**PLEASANT PRAIRIE PLAN COMMISSION MEETING
VILLAGE HALL AUDITORIUM
9915 39th AVENUE
PLEASANT PRAIRIE, WISCONSIN
6:00 P.M.
DECEMBER 9, 2013
AGENDA**

- A. **PUBLIC HEARING AND CONSIDERATION OF A CONCEPTUAL PLAN** for the request of Matt Phillips, agent for Senior Lifestyle Corporation for the proposed Senior Lifestyle Community that will provide 96 senior living dwelling units in phase 1 and 66 dwelling units in phase 2 on the vacant 9 acre property generally located south of Prairie Ridge Blvd. and east of 97th Court within the Prairie Ridge development.

CONSIDERATION OF A CONCEPTUAL PLAN for the request of Matt Phillips, agent for Senior Lifestyle Corporation for the proposed Senior Lifestyle Community that will provide 96 senior living dwelling units in phase 1 and 66 dwelling units in phase 2 on the vacant 9 acre property generally located south of Prairie Ridge Blvd. and east of 97th Court within the Prairie Ridge development.

PROJ. MGR: _____ MDE
 DRAFTED: _____ ALJ
 DATE: 11-1-2013
 CHECKED: _____
 DATE: _____
 2013.0027.04
 SHEET
C-3

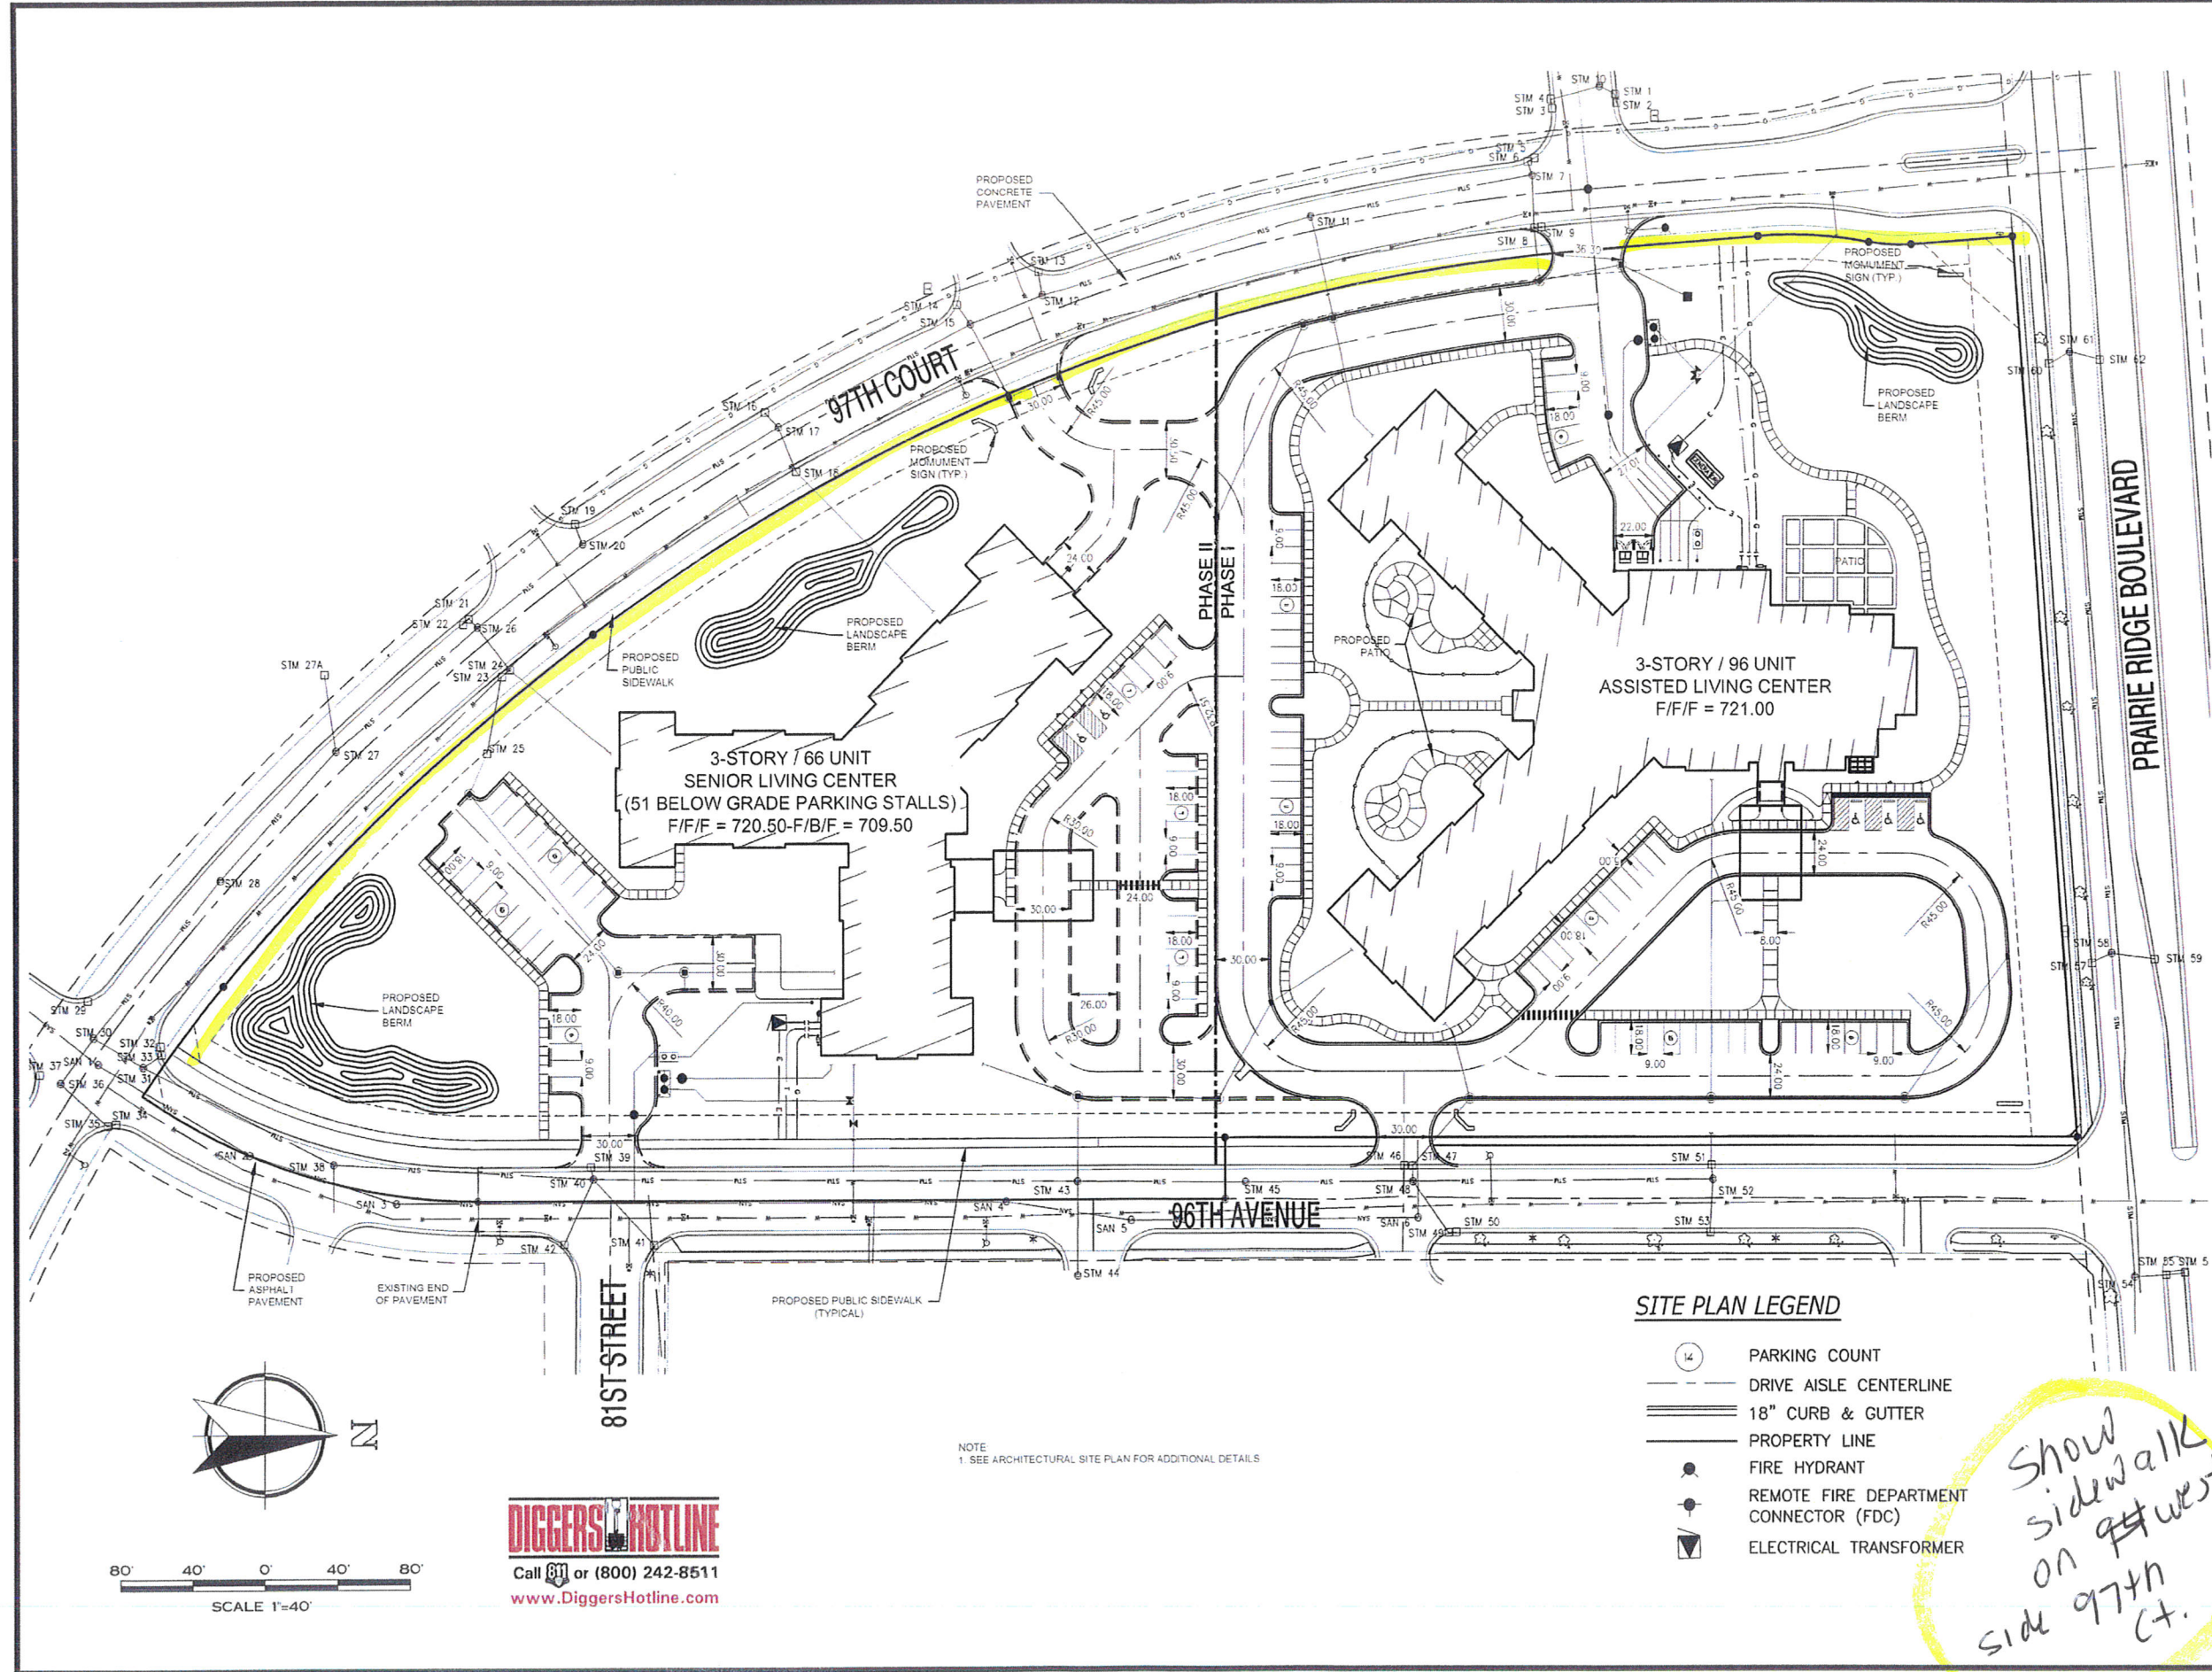
- a. See **attached** changes to sheets **C-3, C-10 and A-2.**
 - b. The renderings and amount of brick work and detail shall be modified on the plans. See **attached** staff mark-up on **Sheet A5.** Additional brick, window modifications, and detailing shall be provided. Sample boards, colors and materials shall be provided for review and approval.

- iv. The 5 ft. wide concrete public sidewalk shall be the dominant improvement when traversing the private driveway entrances on the site. In other words, the concrete sidewalk shall cross through the paved driveways. Depict as such (also depict as such on **Sheet C-3** of the Construction Plans).

1 POST DETAIL (STOP SIGNS)
NOT TO SCALE

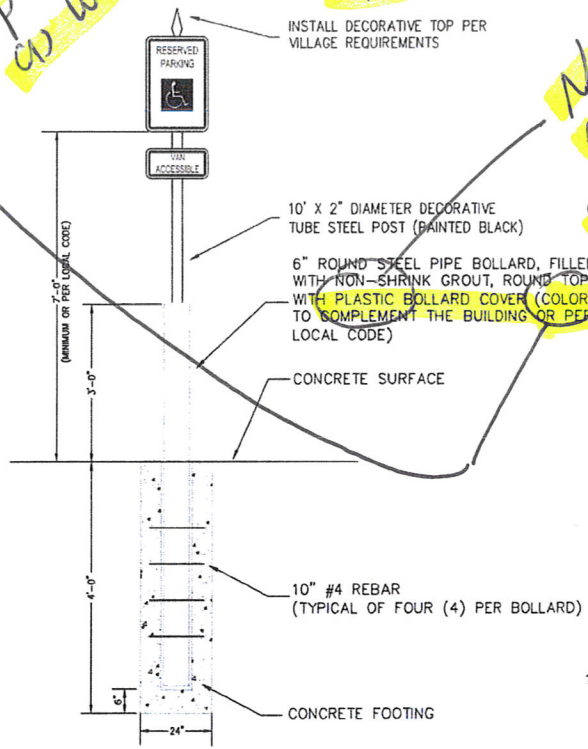
Color samples needed - paint to write
black final
Not plastic steel, metal above grade

1 PROPOSED SITE PLAN
 SCALE: 1/8" = 1'-0"

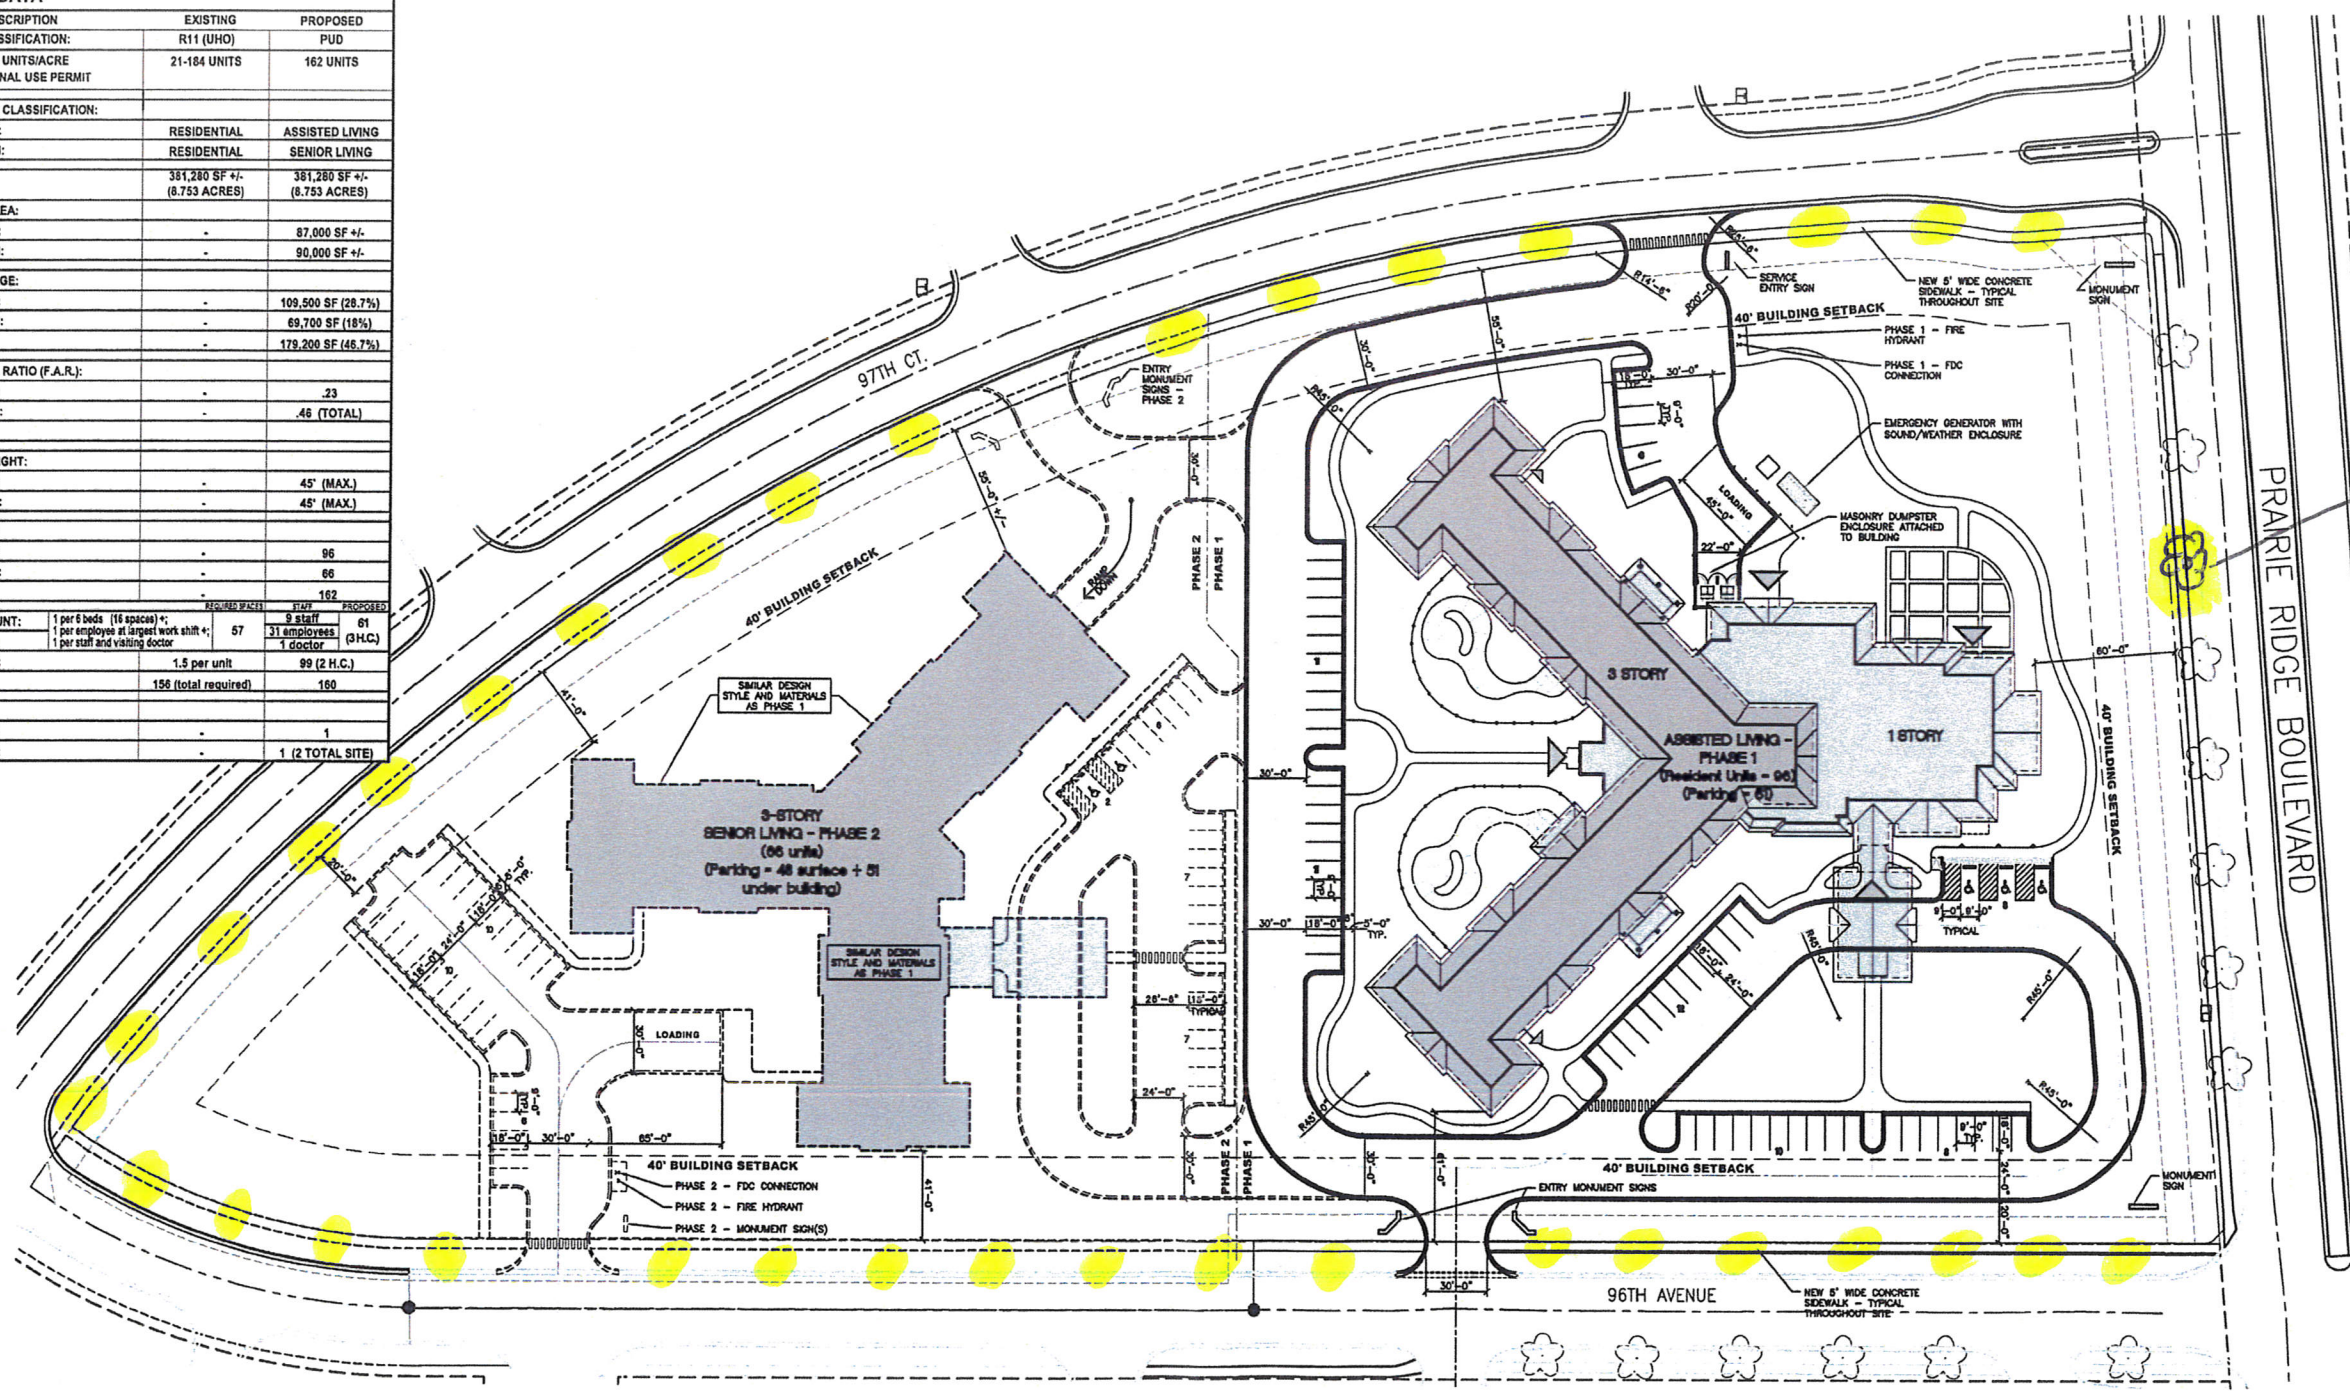
- d. On **Sheet A2** the following changes shall be made:
 - i. In the Zoning Data chart, the Proposed Zoning Classification should be "R-11 (PUD)".
 - ii. The total area of impervious surface shall be provided on the plans.

Street has to be added.

1 OVERALL NEIGHBORHOOD SITE PLAN
SCALE: 1" = 80'-0"

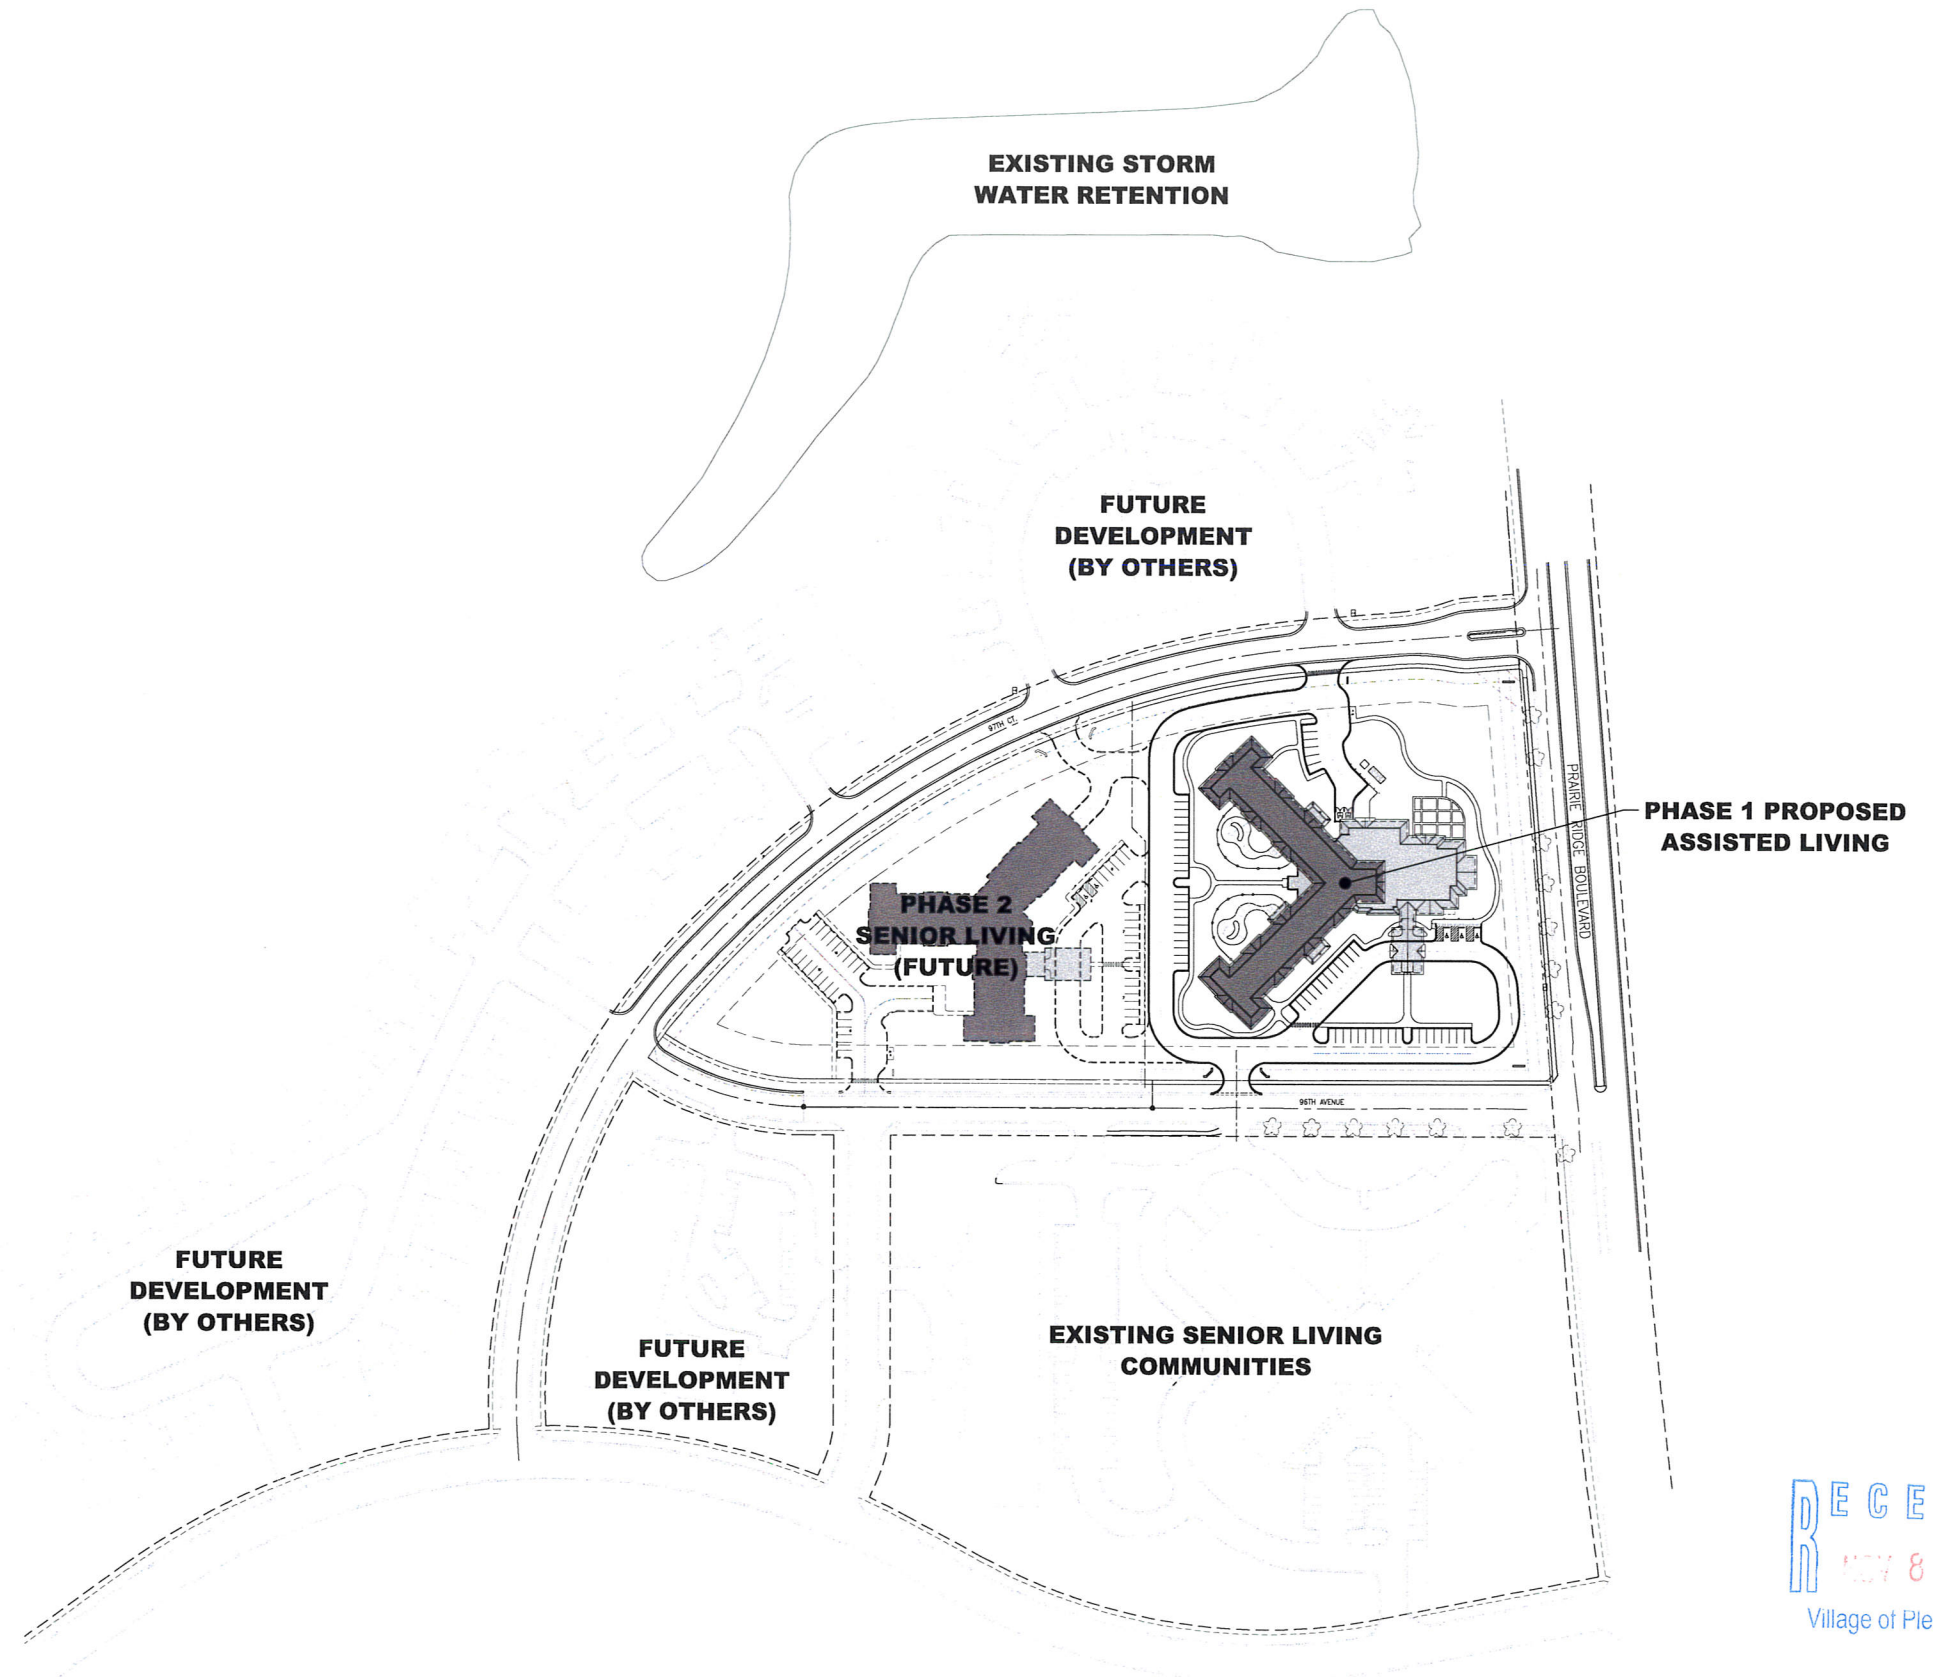
- c. On **Sheet A1:** The depiction of the "Future Development (by others)", the former Arbor Ridge Condominium development, should be eliminated (if it's not planned to be developed in that configuration anymore).
